ADDENDUM NO. 4

Re: Arch Job Number 24001, DCM #2025238, – Plans Dated: 3/31/25

New Lincoln Police Department

Lincoln, Alabama

SHEET
C3.1

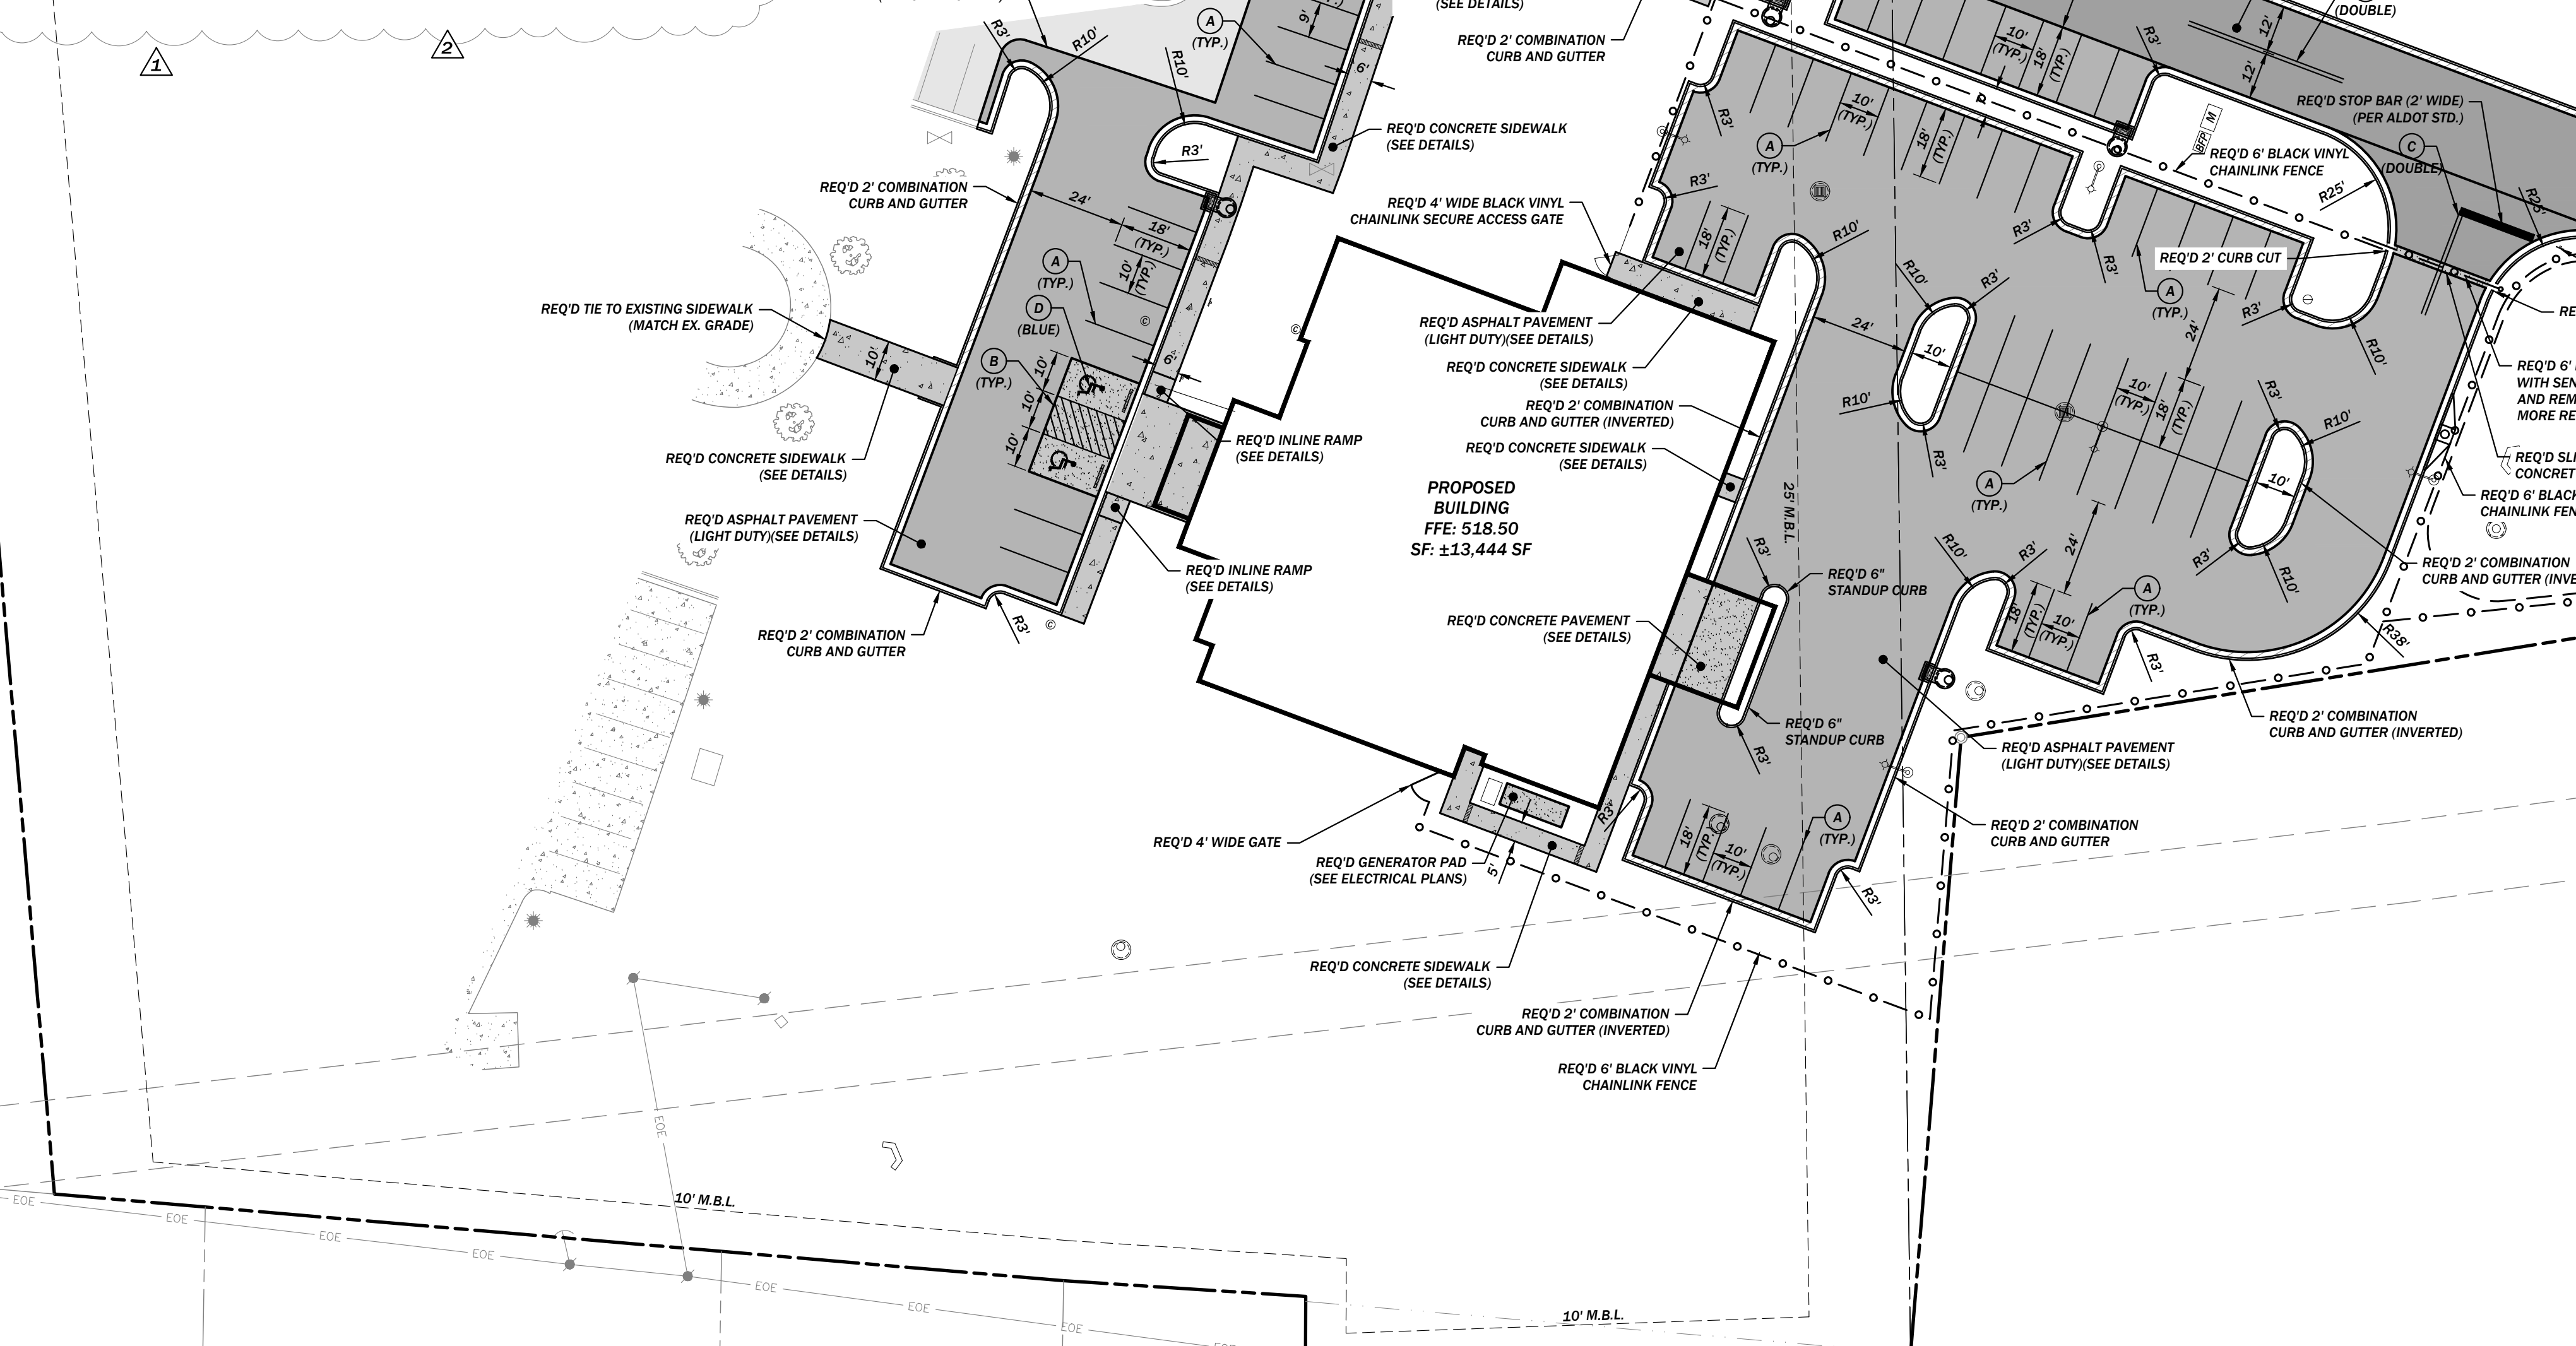
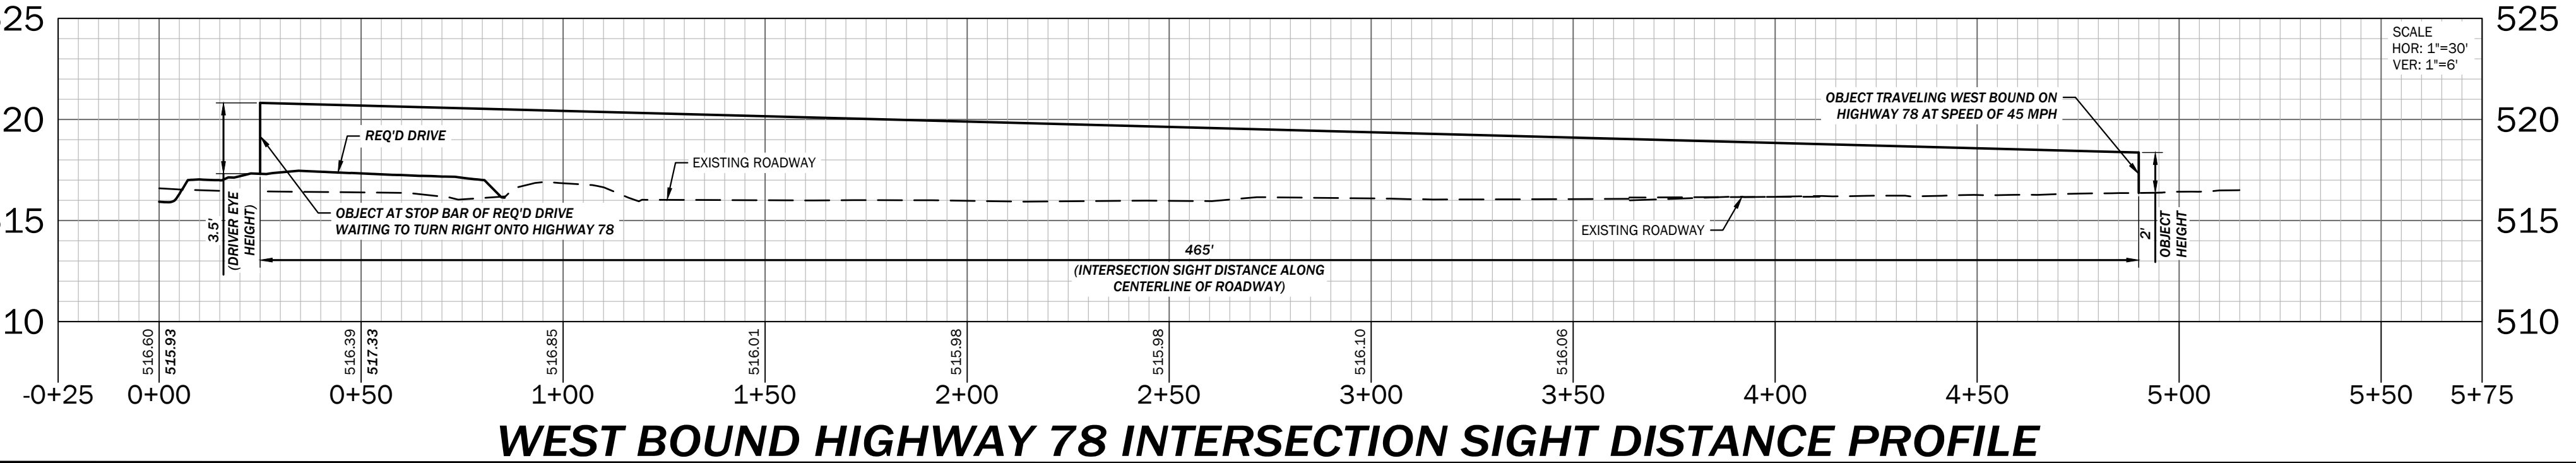
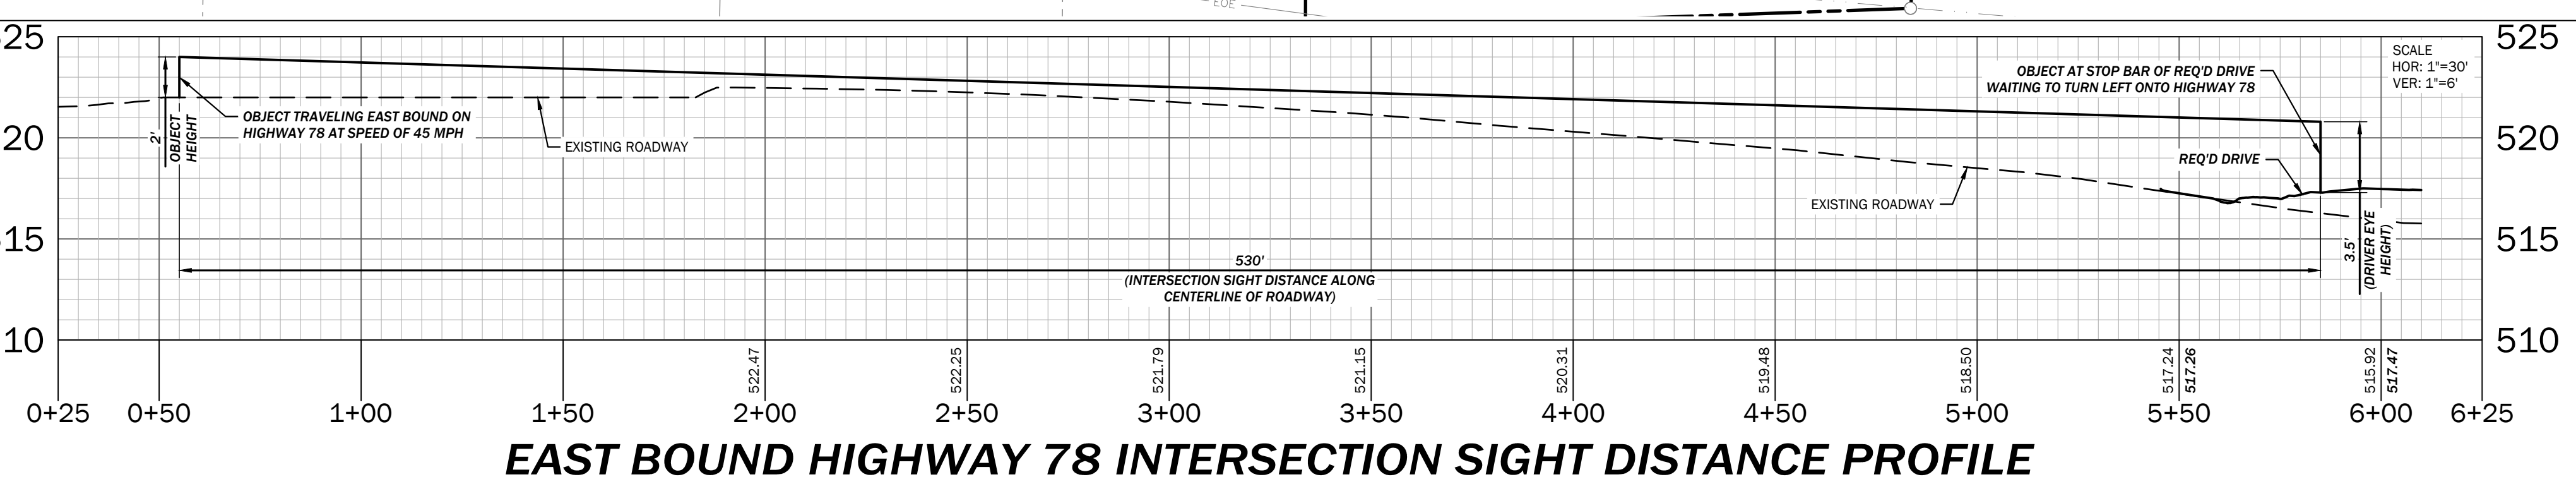
18. Question: Please confirm that drive-way tie-in to US Highway 78 is an asphalt-to-asphalt tie-in, as there are details for valley curb in the civils, but none shown on the plans. Response: All drive connections are from asphalt to asphalt. The valley gutter is in the pond and has been removed.

SHEET
C4.1

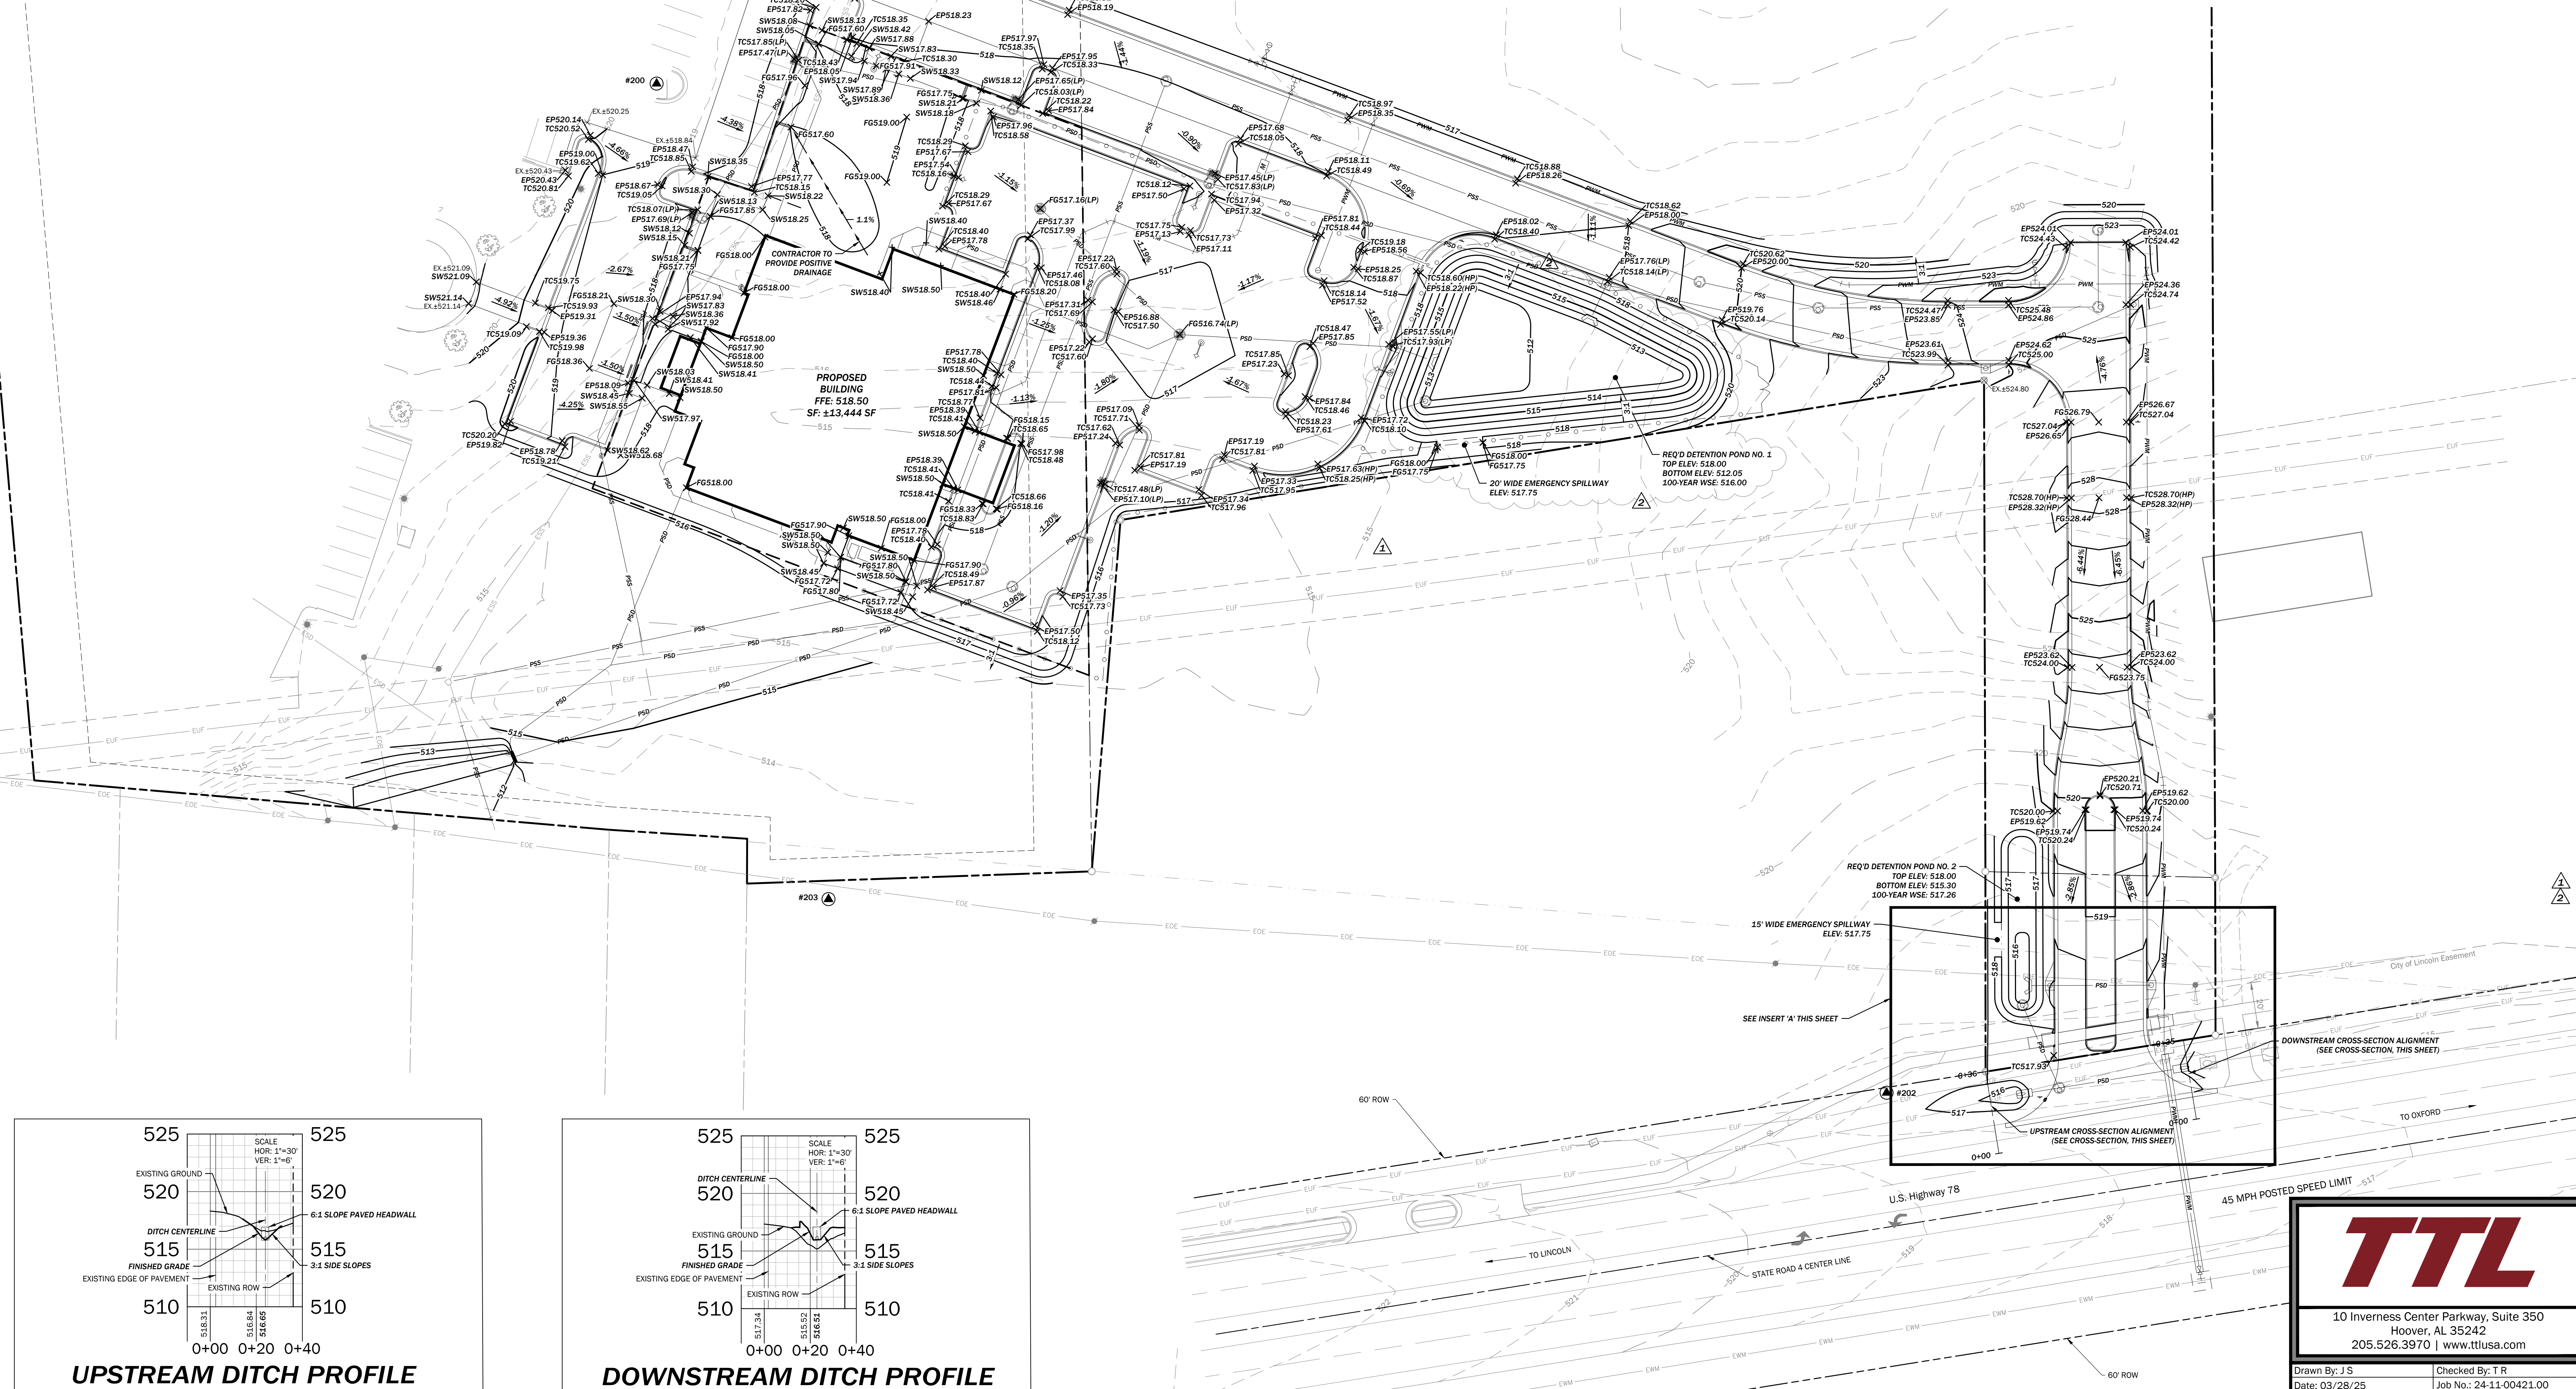
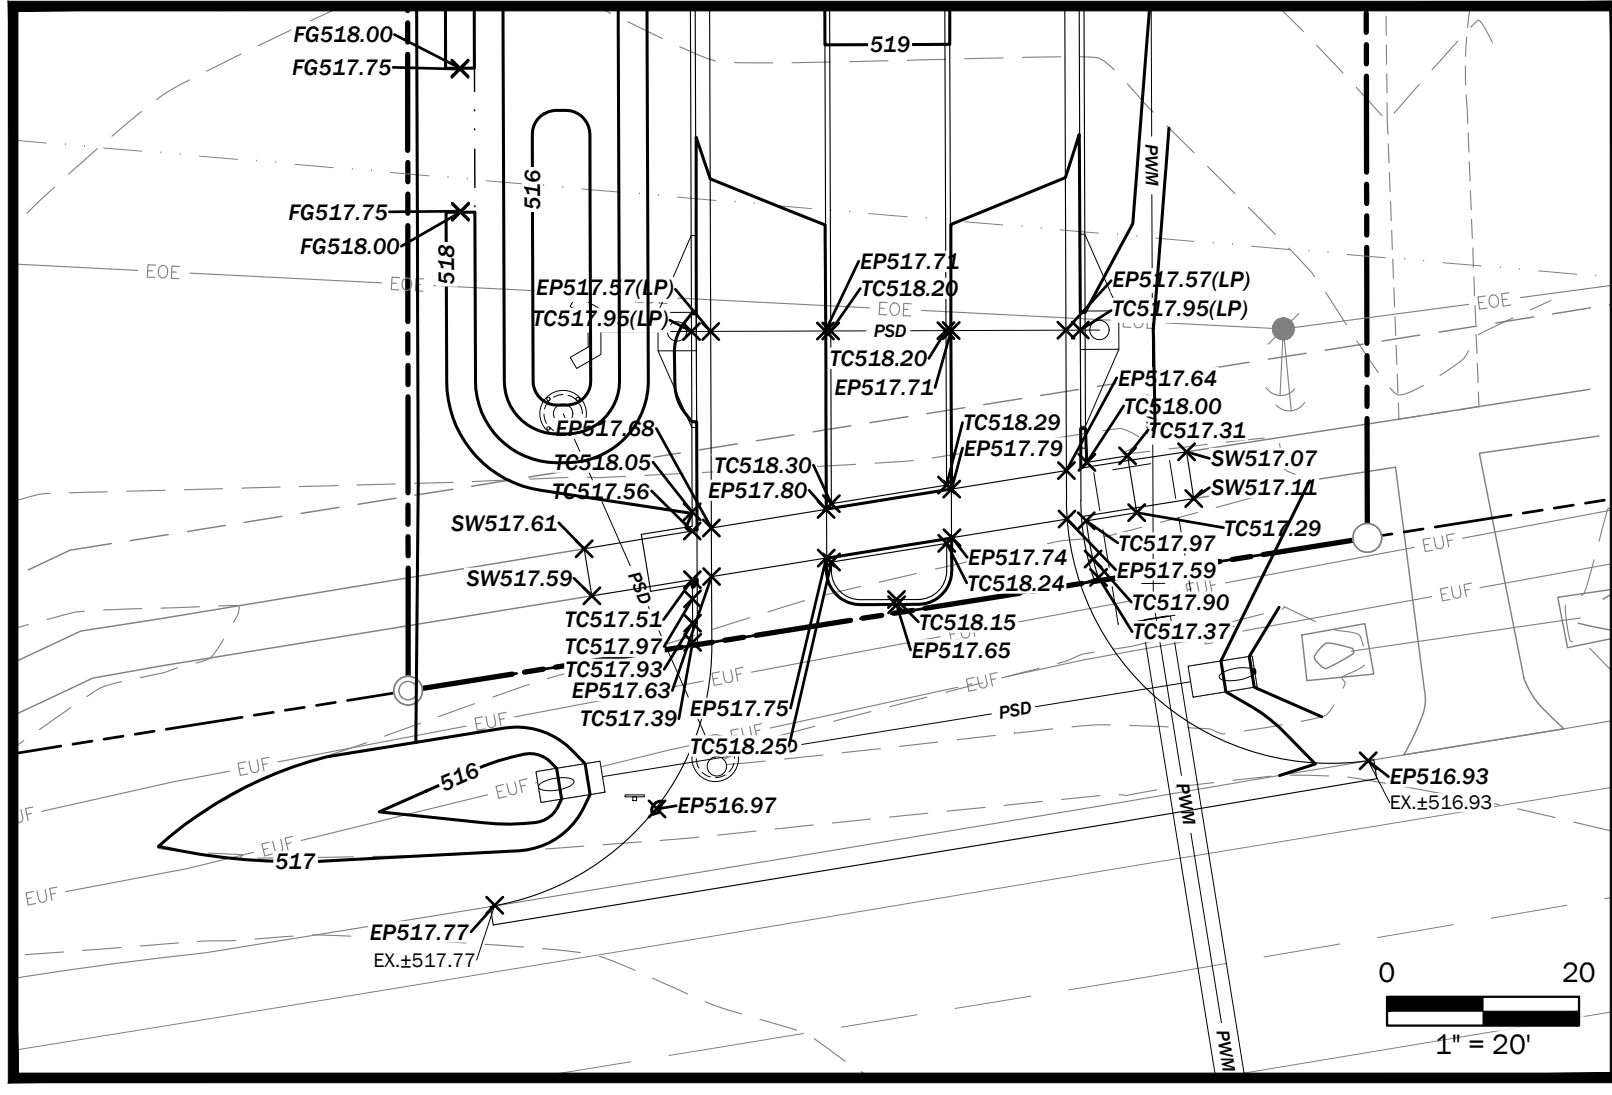
10. Question: Please provide specifications for flagpole. Response: Remove all requirements for flagpole.
11. Question: What are the landscaping requirements? This must be determined prior to completion of grading work, as sleeves for irrigation will be required. An allowance is suggested for the bid. Response: Sod will be required around the building, see Erosion Control Plan issued as part of this addendum. Irrigation sleeves have been added to the drawings for future work.
